RE: WILLOUGHBY CITY COUNCIL DA 2010/34 – STORMWATER COMMENTS

Drawing Title	HYDRAULIC SERVICES DETAIL SHEET
Drawing No.	09S693 DA-H

Subject: FW: (DWS Doc No 12094252) DA - 2010/34 - JRPP Report - Conditions of Consent Amendments

3 ORIFICE PLATE DETAIL
SCALE 1:20

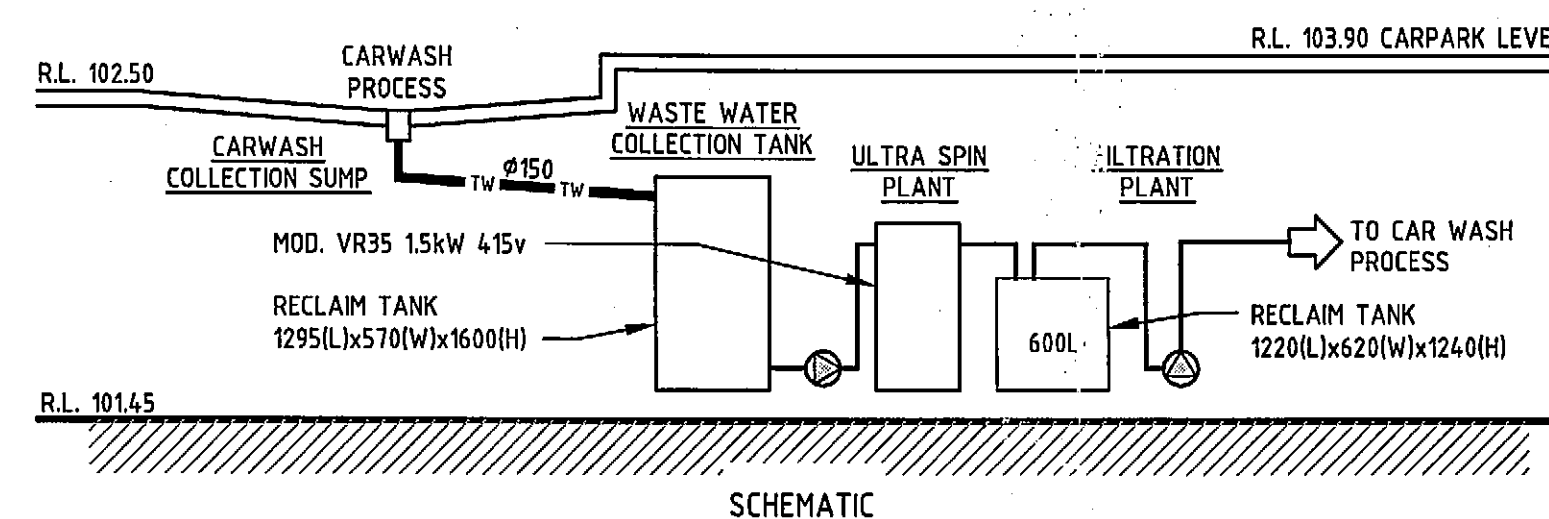
- i) The high early discharge pit has been deleted and the orifice recalculated.
Our detail of the orifice plate installation has been altered to show no silt trap and that after the orifice plate has been installed and approved the sump shall be benched to fall to the orifice.
- ii) The invert level of the rainwater tanks overflow is now 100mm above the OSD overflow weir height.
- iii) A copy of the hydraulic grade line analysis has now been placed on our drawing H-10.

MATERIAL = GRADE 304 STAINLESS STEEL PLATE 6mm THICK
ORIFICE = 199mm MACHINE CUT FINISH TO ORIFICE
COEFFICIENT = 0.61 DEPTH OF WATER OVER ORIFICE

WESTERN WA
PROPOSED HYDRAULIC GRADE LINE
CROSS SECTION
SCALE H- 1:200

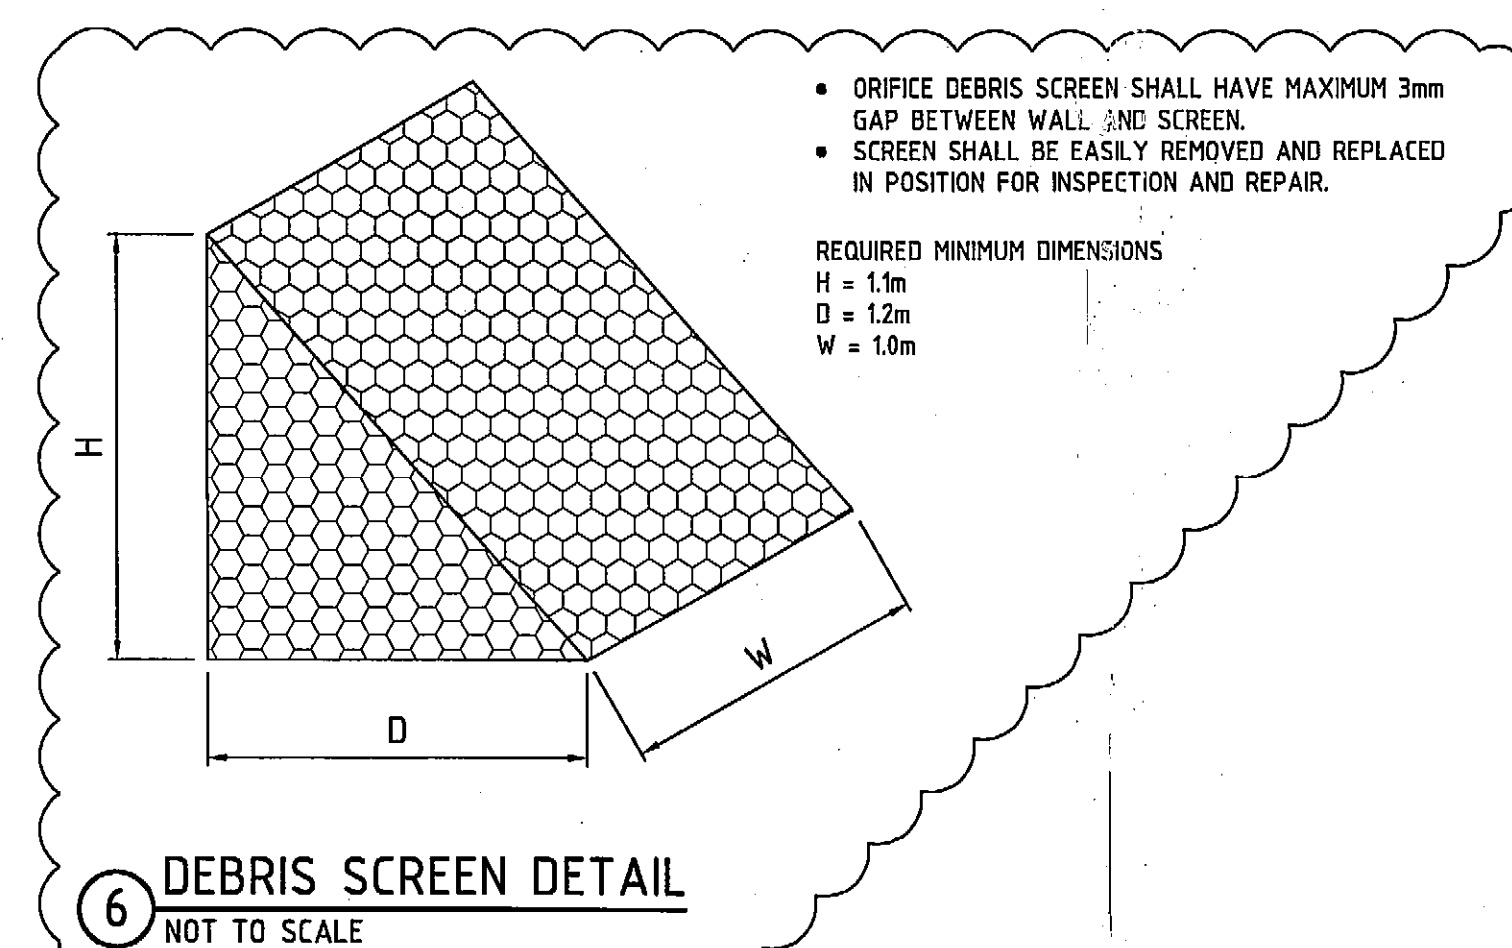
The HGL demonstrates that backwater effect will not occur from the council's drainage pit in western way to the proposed OSD system.

EXTENT OF PROPOSED ENCROACHMENT OF ROOF
(10.5 m ABOVE STREET)
SHOWN SHADED

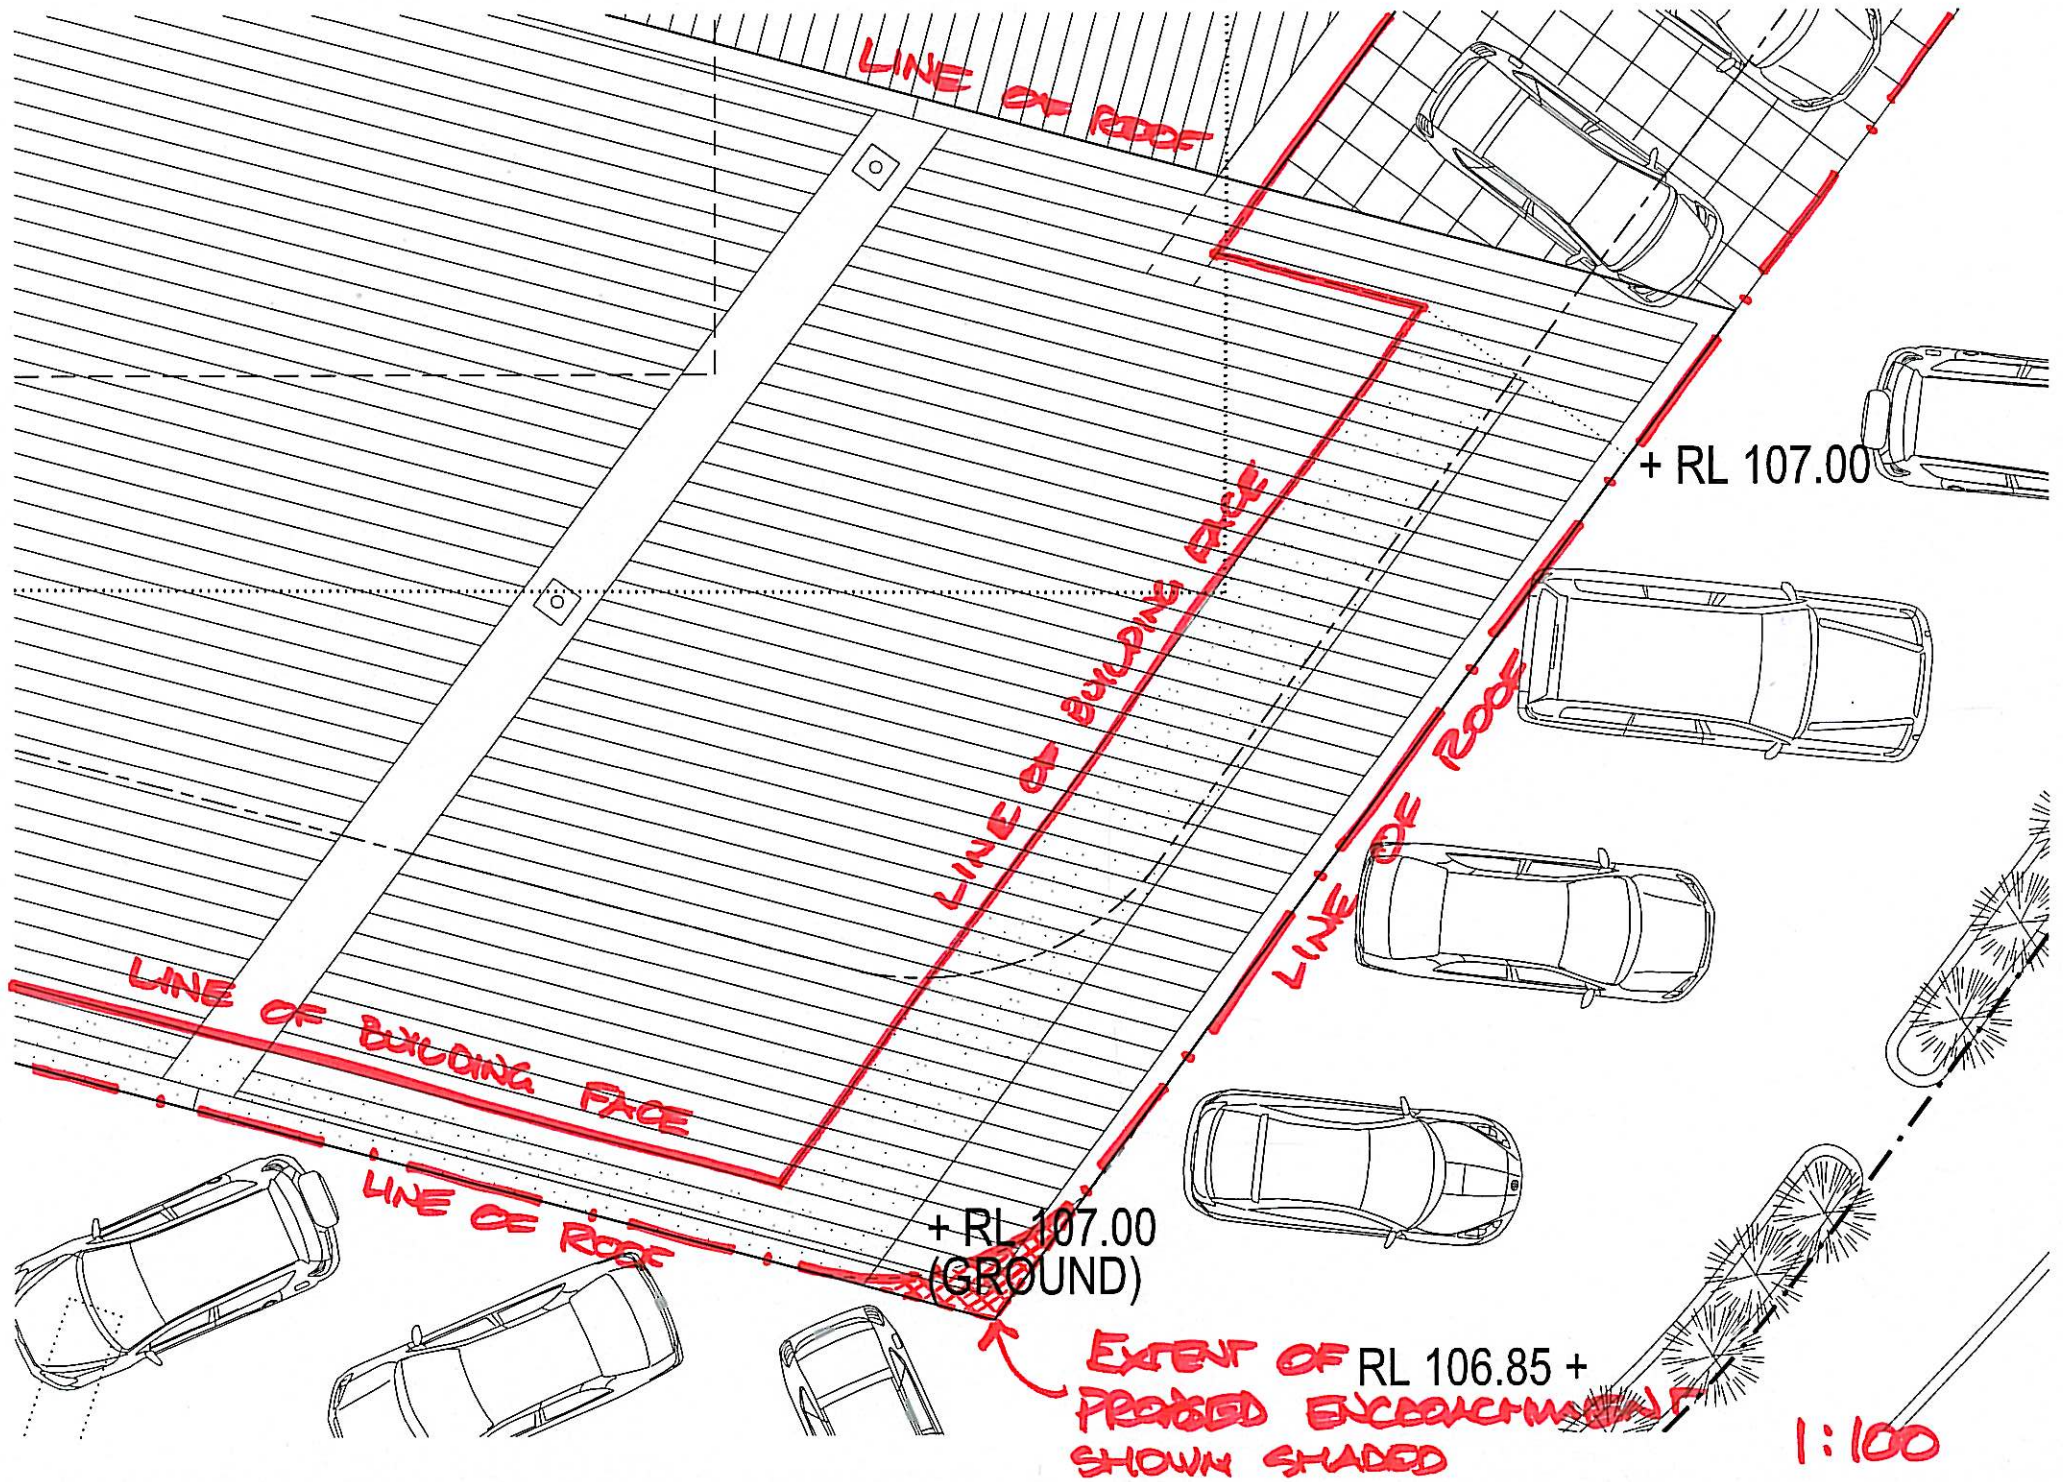
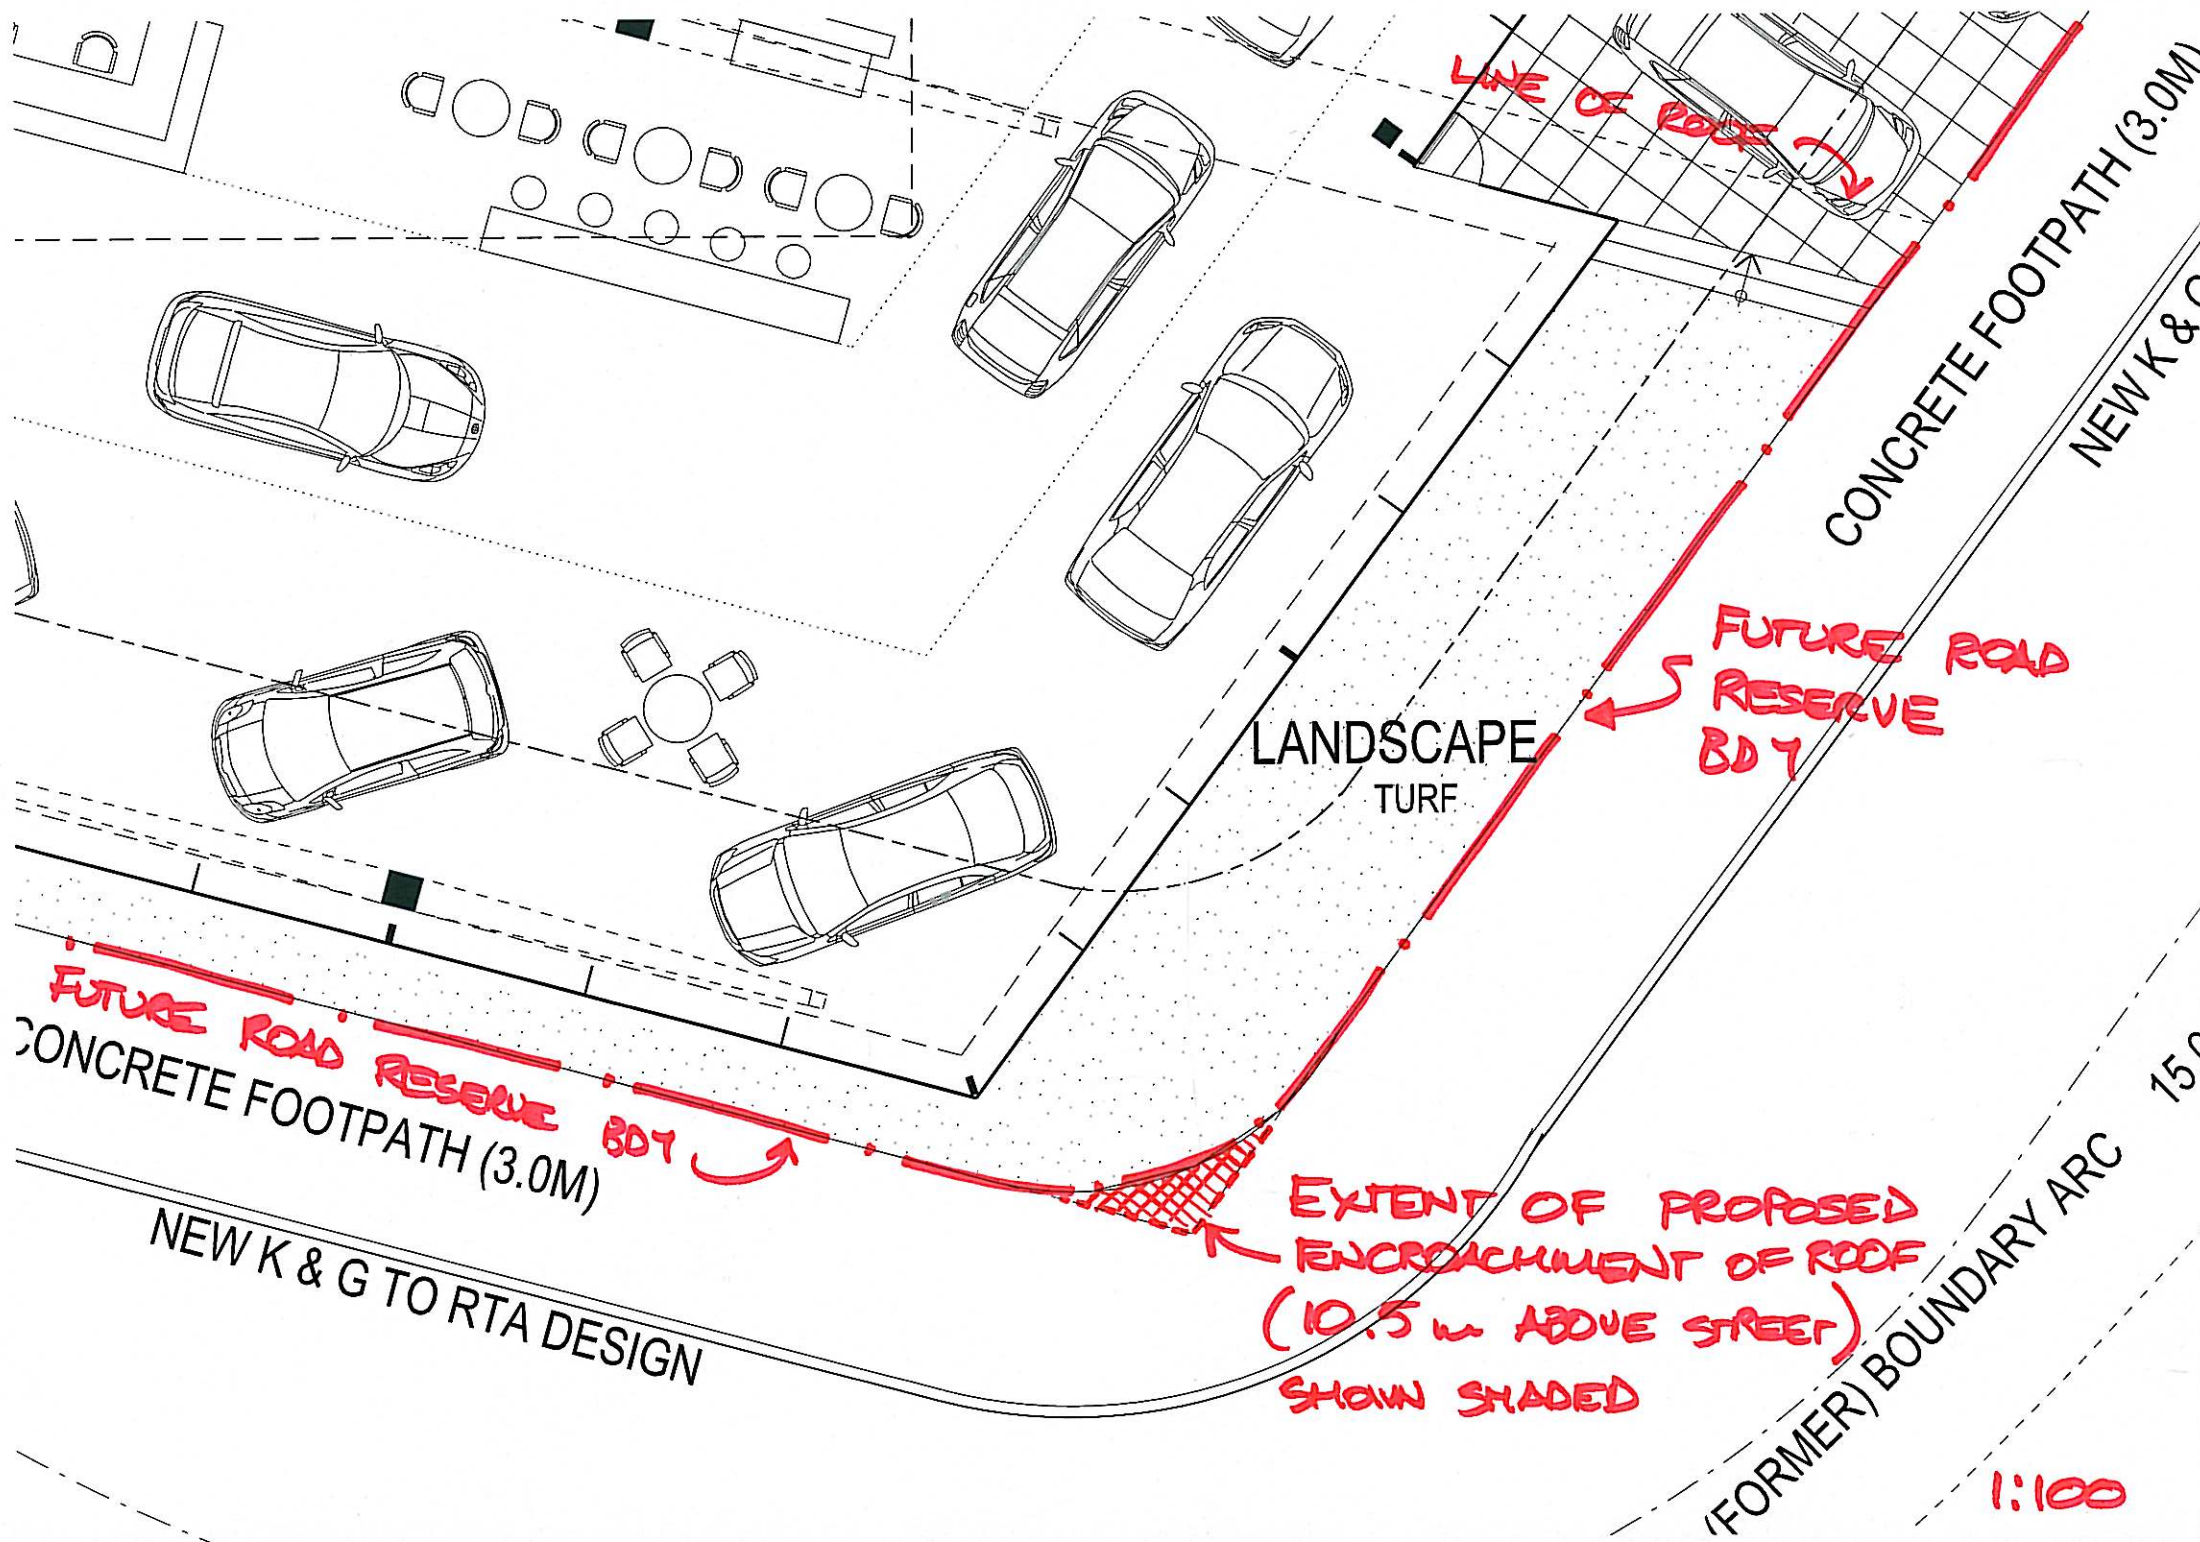
The item (f) requiring amendment of the roof design to remove the encroachment into the road reserve is problematic and compromises the design, both in terms of architecture as well as functional intent.

To 'trim' the roof back to avoid the minor encroachment (refer to the attached sketches) will require a substantial change to the roof form, affectively halving the current proposed roof eaves.

From an architectural position, this greatly changes the impact of the roof to the intersection which is seen as a principle element.

To alter the roof geometry (to trim the roof edge back on an angle or to chamfer) is not considered to be a solution, to do so destroys the simple roof form.

From a functional position, this reduces the shading achieved to the northern façade, which in turn will impact on the energy efficiency outcomes of the showroom.

Given the controls for street awnings, where there is provision for building elements to overhang the footpath, we consider this minimal encroachment to be of a similar circumstance – however this is 10.5 metres above the road.
